Subject: Cable Tray Support and Electrical Review Questions
Comanche Peak Steam Electric Station
Independent Assessment Program - Phase 4
Texas Utilities Generating Company
Job No. 84056

ATTACHMENT A

CABLE TRAYS - AS-BUILT ISOMETRICS
 AUXILIARY BLDG. FL 790'-6"
 REF. DWG. FSE - 00174

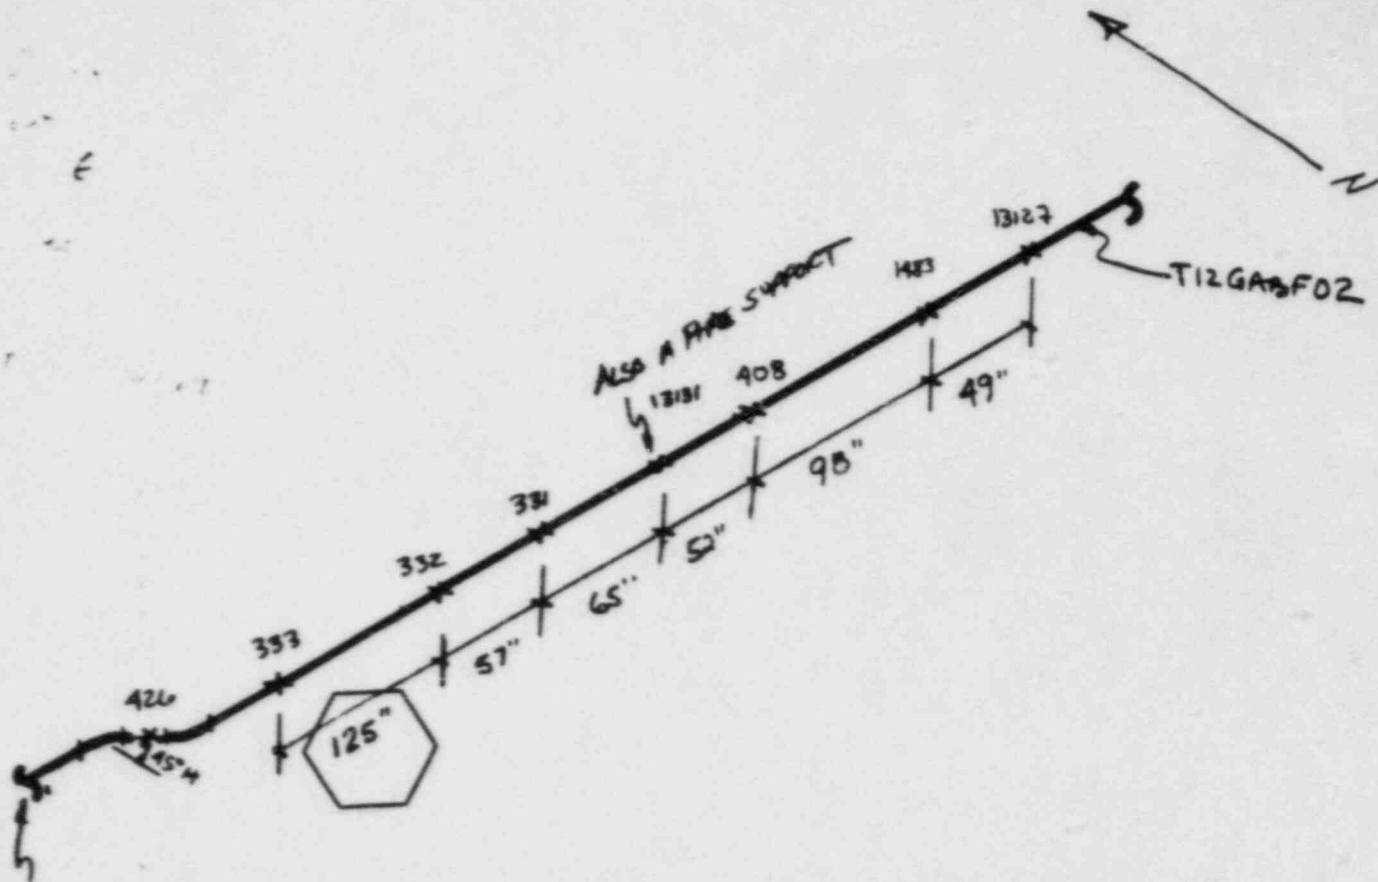
Ref. Dwg. No.	Cygna Iso. Sht.	Tray Seg. No.	Span	Supports No. Starting	Supports No. Ending	Fire Protection
FSE-00174	1	T120ABC03	11'-0"	299	479	Yes
FSE-00174	2	T12GABF04	10'-5"	333	332	Yes
FSE-00176	4	T110SAA15	8'-4"	592	593	No
FSE-00176	4	T110SAA13	12'-0"	655	656	No
FSE-00176	5	T120SBC36	8'-8"	764	765	No
FSE-00176	5	T120SBC25	8'-4"	724	726	Yes
FSE-00176	5	T120SBC25	8'-2"	722	723	Yes
FSE-00176	6	T120SBC29	9'-3"	620	587	No
FSE-00185	7	T120ABC10	8'-9"	2986	2998	Yes
FSE-00185	7	T120ABC17	10'-0"	2953	2990	Yes
FSE-00185	8	T110AAA08	8'-10"	2992	2993	Yes
FSE-00185	8	T110AAA10	9'-4"	3134	2861	Yes

Ref. Dwg. No.	Cygn Iso. Sht.	Tray Seg. No.	Span	Supports No. Starting	Supports No. Ending	Fire Protection	Comments
FSE-00174	1	T120ABC04	11'-10"	---	---	Yes	No longit. support on run between riser at CTH 367 and horiz. elbow at CTH 479.
FSE-00174	2	T12GABF01 to T12CABF04	40'	---	---	Yes	No longitudinal supports in this entire run from col. lines F-A through K-A.
FSE-00174	3	T12GABF33	48'	489	---	Yes	Span exceeds 40' from a longit. support to the elbow at CTH 124.
FSE-00176	4	T110SAA18	5'	---	---	No	No longitudinal support between elbow at CTH 589 and end of run at CTH 720.
FSE-00176	4	T110SAA11	60'-5"	3134	5807	No	Longitudinal span exceeds 40'-0"
FSE-00176	5	T120SBC25	57'-5"	2920	13080	Yes	Longitudinal span exceeds 40'-0"
FSE-00176	6	T120SBC29	60'-2"	586	587	No	Longitudinal span exceeds 40'-0"
FSE-00185	8	T110AAA08	10'-4"	---	---	Yes	No longitudinal supports on run between elbow at CTH 2923 and wall penetration at col. line F-A

- (a) Justification for the increase in transverse and longitudinal spans beyond rated allowables;
- (b) Justification for using allowable longitudinal spans based on non-fire-protected tray loadings for those longitudinal spans which are additionally loaded with fire protection; and,
- (c) Assurance that longitudinal supports for fire-protected tray runs are adequately reviewed for the addition of the fire barrier under TUGCO Engineering Instruction CP-EI-4.0-49, Rev. 1.

CABLE TRAYS - AS BUILT ISOMETRICS
 AUXILIARY BLDG., EL 790'-6"
 REF. DWG, FSE-00185

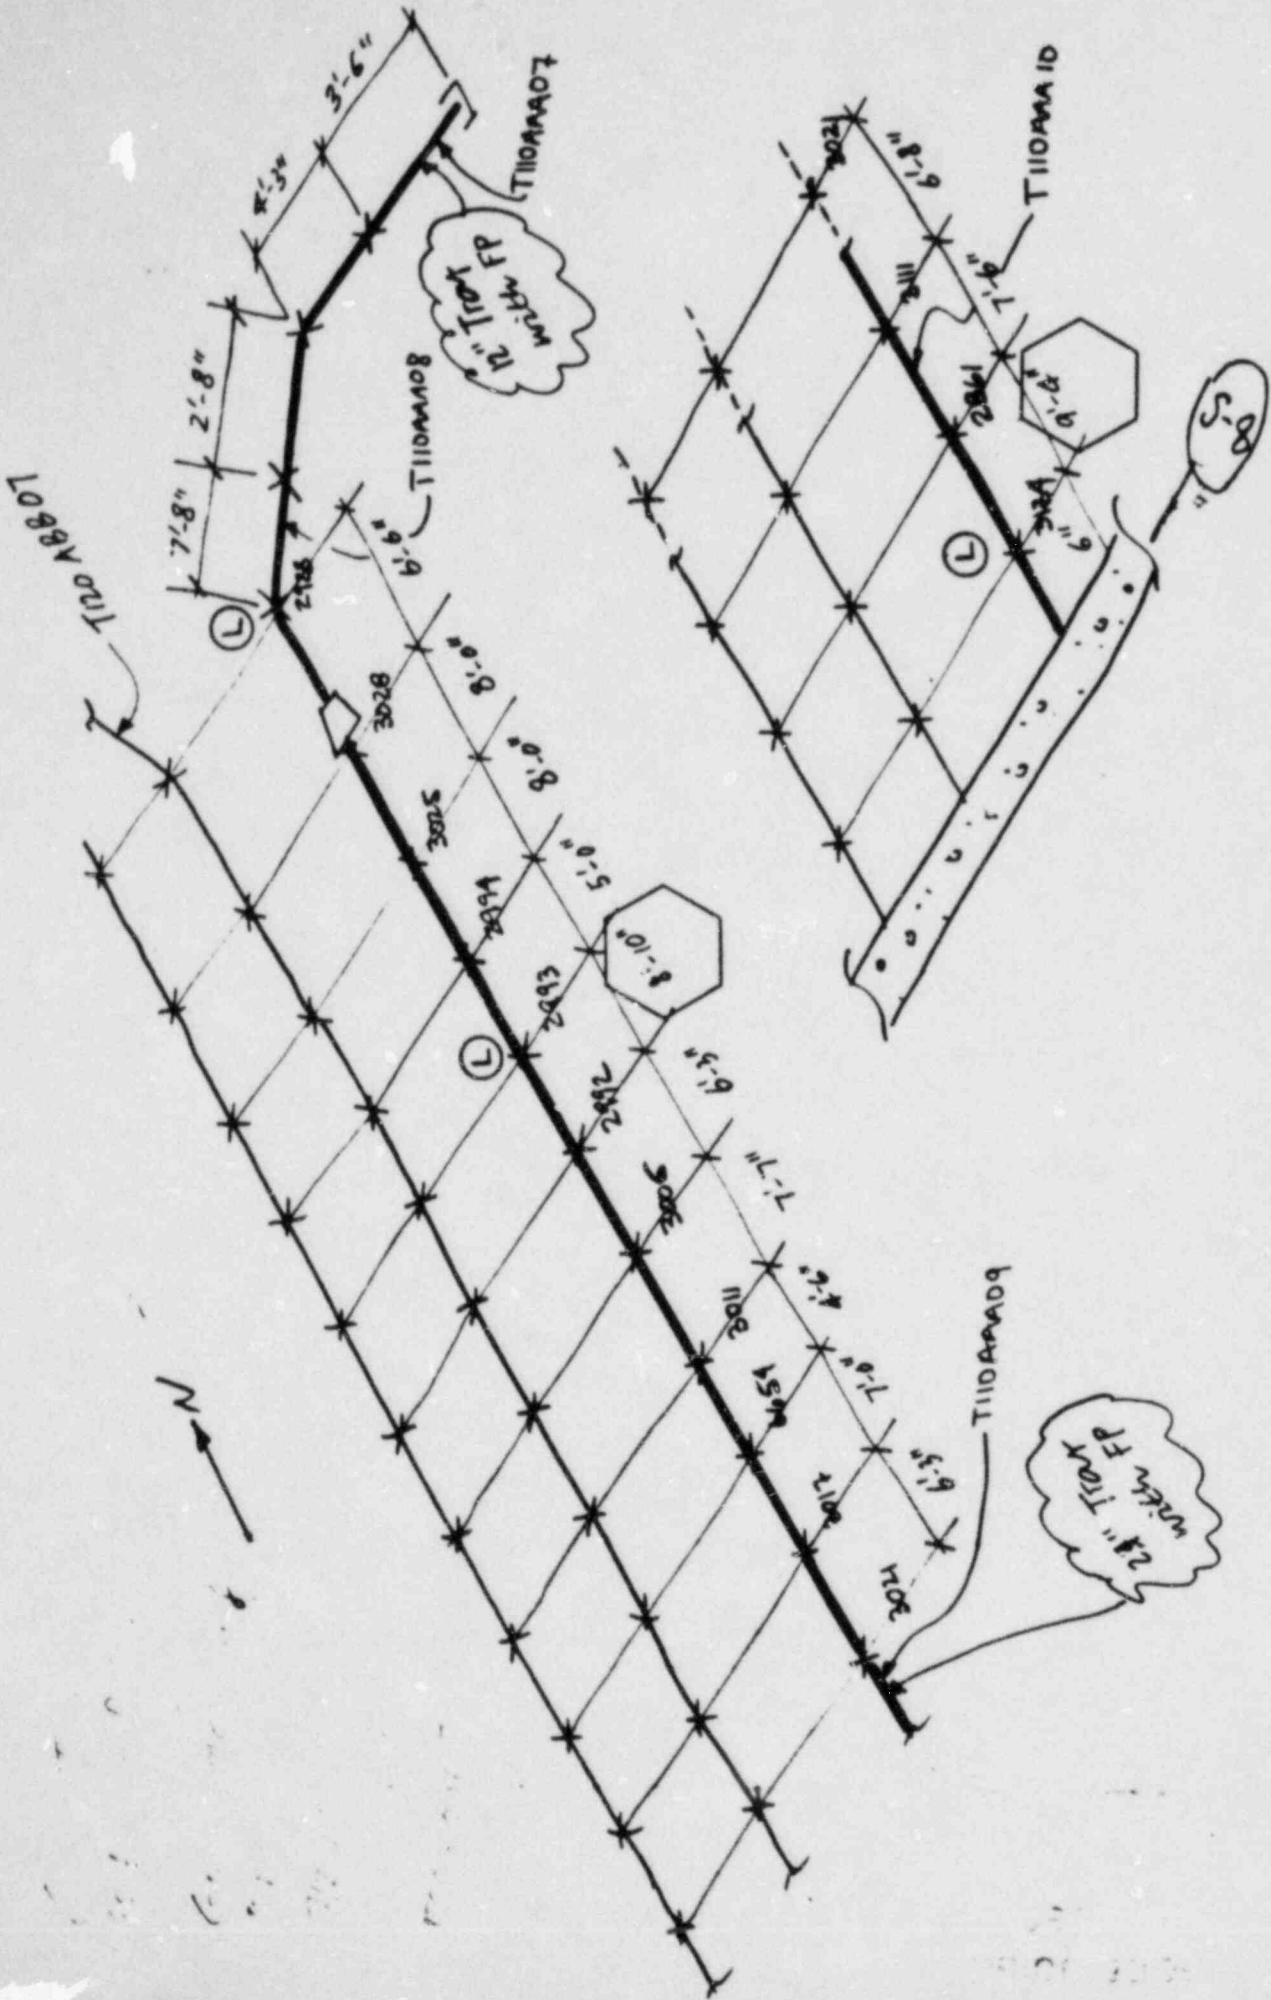
FSE-00185	8	T110AAA10	63'-11"	2993	3134	Yes	Longit. span exceeds 40'-0"
